MONITORING YEAR 2 ANNUAL REPORT

Anderson Farm Mitigation Site

Wayne County, NC
NCDEQ Contract No. 0402-10
DMS ID No. 100180
DWR No. 2021-0023v2

Subject: Task 6 Draft Monitoring Year 2 Report Comments – Anderson Farms Mitigation Site (DMS #100180)
Neuse River Basin: 03020201; Wayne County, NC
Contract No. 0402-10

Figure 1. Vicinity Map
Anderson Farm Mitigation Site
Monitoring Year 2 - 2023
Neuse River Basin (03020201)

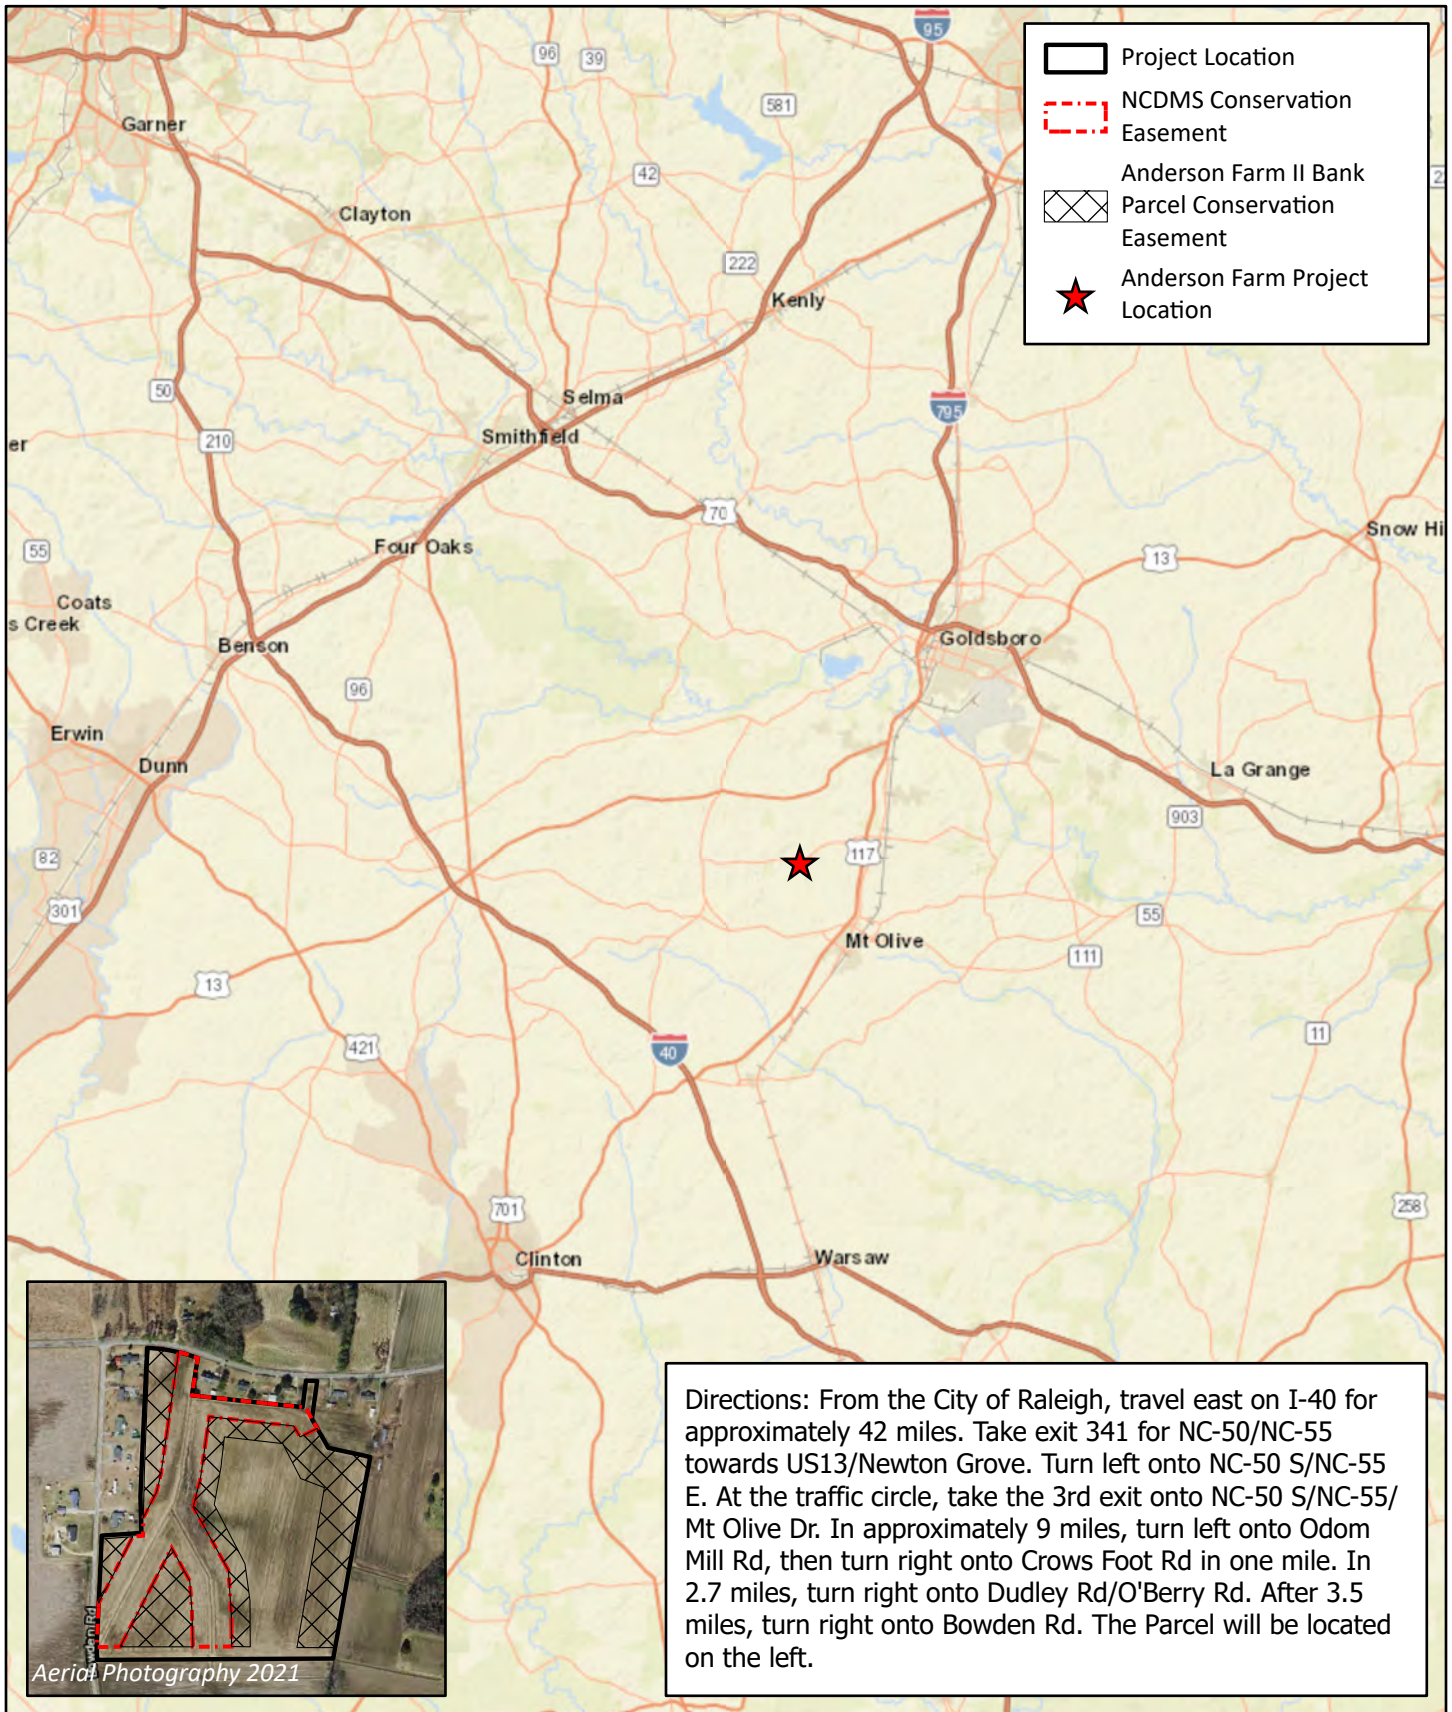
1. Please add the surrounding bank easement to the CCPV.

Response: The CCPV has been updated to display the surrounding bank easement. Additionally, figures 1 and 3 have been updated to display the bank easement.
